ALERT SERVICE BULLETIN

ASB UH-1H-23-22

MODEL AFFECTED: UH-1H

SUBJECT: TENSION ROD ASSEMBLY P/N 205-030-249-009 OR 205-030-249-013, INSPECTION OF.

FIGURE 1. Inspection requirements.

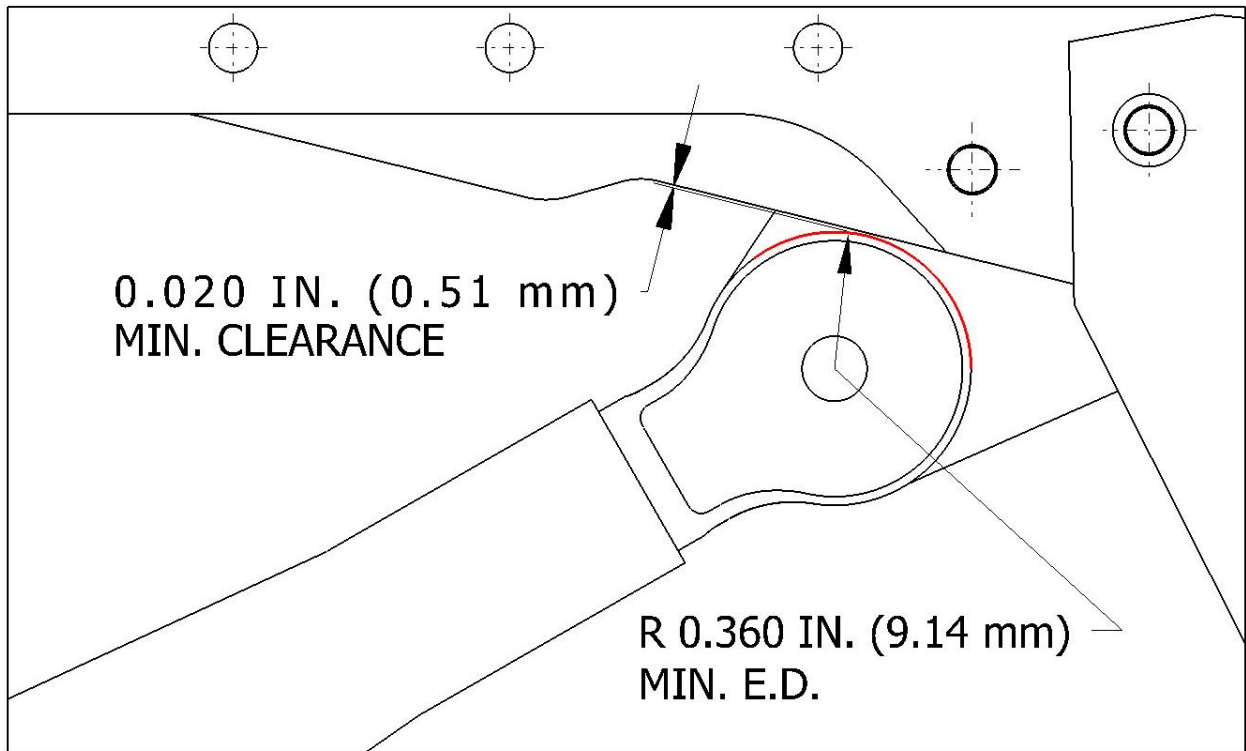
2. Inspect the forward end (upper attachment location) of the tension rod assembly as follows:
 - a. Inspect the outboard side of the tension rod assembly rod end for a possible over trimmed condition. Minimum acceptable radius dimension measured from the bolt hole center is 0.360-inch (9.14 mm) edge distance (E.D.) (Figure 1). Removal of the attachment bolt may be required to perform this measurement. Record findings. During reinstallation of hardware, if required, tighten the nuts IAW appropriate instructions. [QA]

- b. Check for fouling or low clearance conditions between the rod end and the structure (cap, web, angle). Minimum acceptable clearance is 0.020-inch (0.51 mm) (Figure 1). Record findings.

FIGURE 2. Inspection requirements

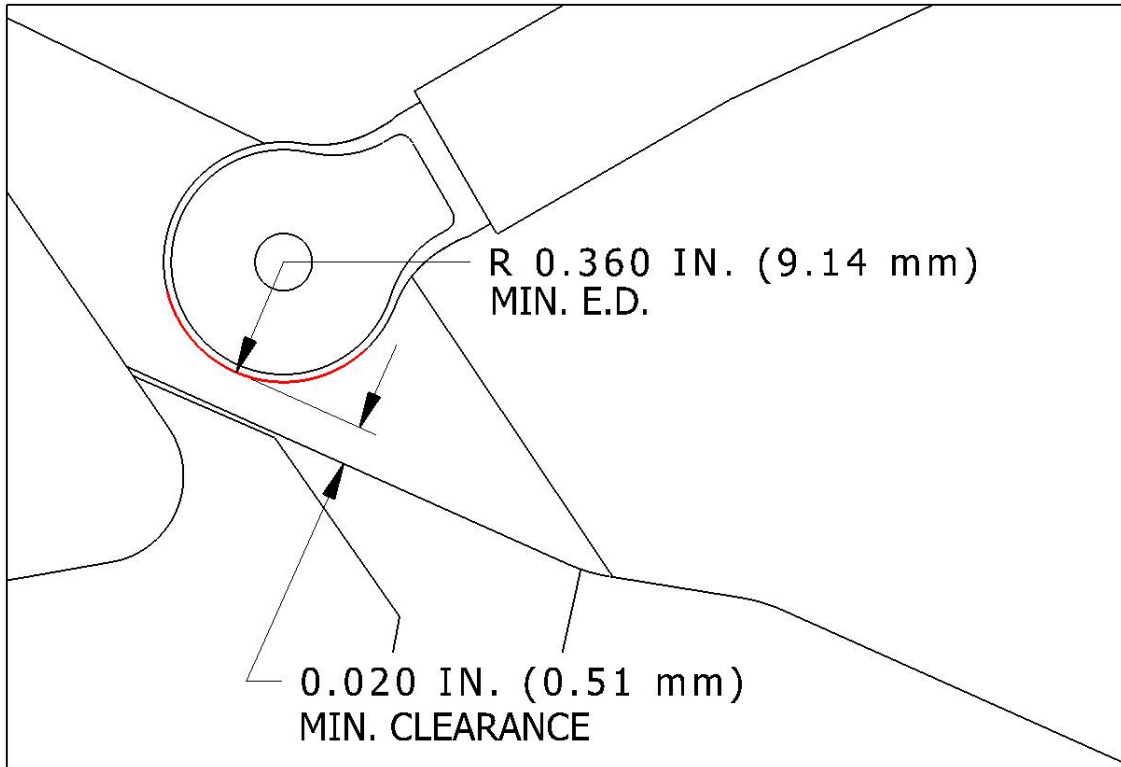
3. Inspect the aft end (lower attachment location) of the tension rod assembly as follows:
 - a. Inspect both sides of the tension rod assembly rod end for a possible over trimmed condition. Minimum acceptable radius dimension measured from the bolt hole center is 0.360-inch (9.14 mm) edge distance (E.D.) (Figure 2 and 3). Removal of the attachment bolt may be required to perform this measurement. Record findings. During reinstallation of hardware, if required, tighten the nuts IAW appropriate instructions. [QA]

- b. Check for fouling or low clearance conditions between the rod end and the structure (cap, web) on the outboard side and the fillet radius on the inboard side of the fitting. Minimum acceptable clearance is 0.020-inch (0.51 mm) (Figures 2 and 3). Record findings.

FIGURE 5. Rework requirements
KEEP 0.280 IN. (7.11 mm) MIN. E.D.
FOR FASTENERS (CAP, WEB, ANGLE)

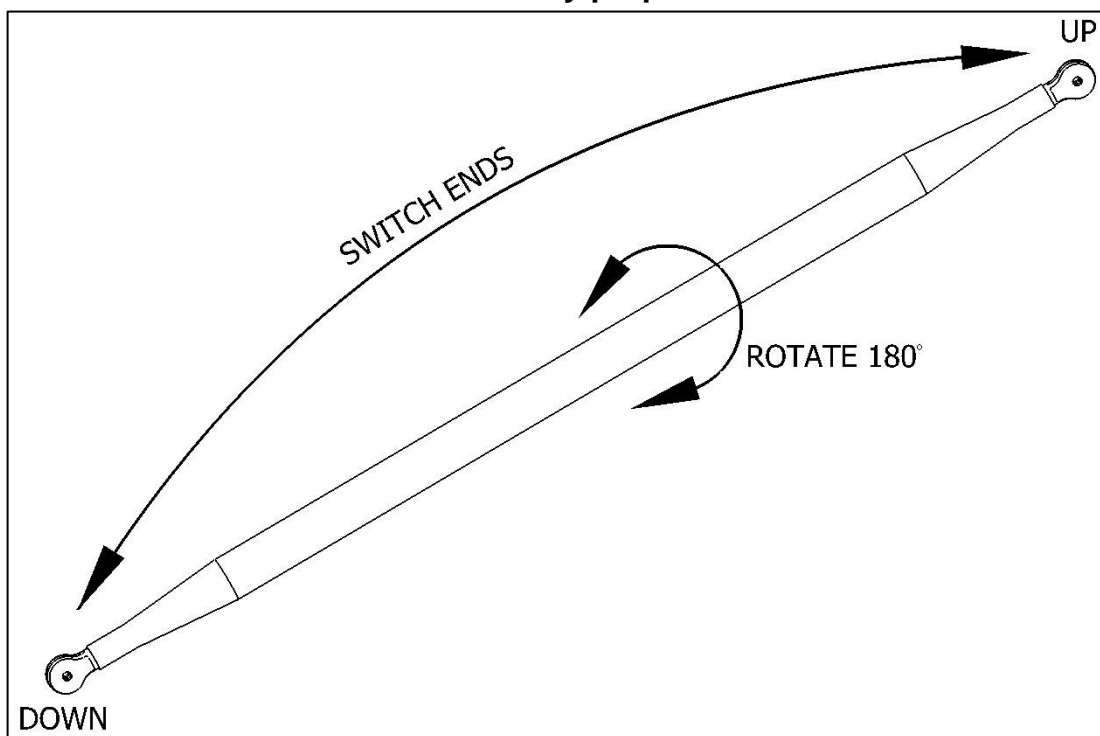
3. Temporarily reinstall tension rod assembly. Mark the minimum material removal required on the affected rod end and/or structure attachment points to obtain the required clearance. (Figure 5 for the upper bolt. Figures 6 and 7 for the lower bolt.)
4. Remove the tension rod assembly (step 1.a.).
5. Trim and deburr previously marked material on the affected rod end and/or structure attachment fitting. Ensure the inspection criteria defined in **PART I** are respected (Figures 1, 2, and 3).
6. Apply chemical film and one coat of epoxy polyamide primer to the reworked area.
7. Install the tension rod assembly (step 2.a.).
8. Make an entry in the helicopter logbook and historical service records indicating compliance with this Alert Service Bulletin.
